# Lubbesthorpe Parish Council

# **Planning Committee Meeting**

**Venue:** The Hub, Tay Road. Lubbesthorpe **Meeting Time:** 6.00pm Tuesday 22<sup>nd</sup> November 2022.

- **3. Declarations of Interest.** None in relationship to the planning applications discussed.
- 4. To decide upon responses to planning applications received from Blaby District Council including 22/0827/rm Local Centre 1 The Council agree to support this planning application. The Council feel that this is a much paeded exect to the community and here that is will go through the support to the community and here that is will go through the support to the community and here that is will go through the community and here that is will go through the community and here that is will go through the community and here that is will go through the community and here that is will go through the community and here that the community and here that the community and here that the community and here the community are the community and here the community are the community and here the community are the community ar

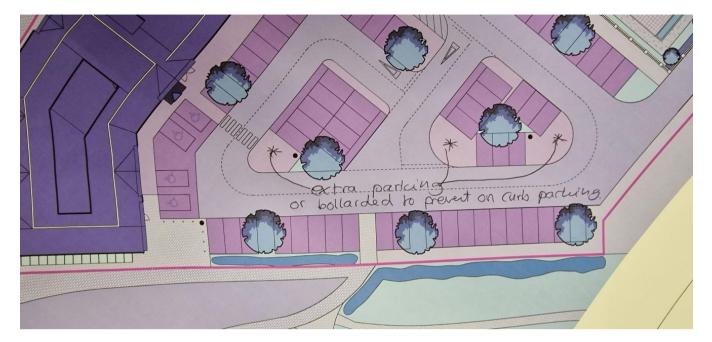
The Parish Council makes the following suggestions as to where extra parking could be accommodated relatively easily.

- More parking in the corners within the carpark (approx. 3 spaces), please see picture 1
- Additional parking along the north side boundary (approx. 30 spaces) please see picture 2.
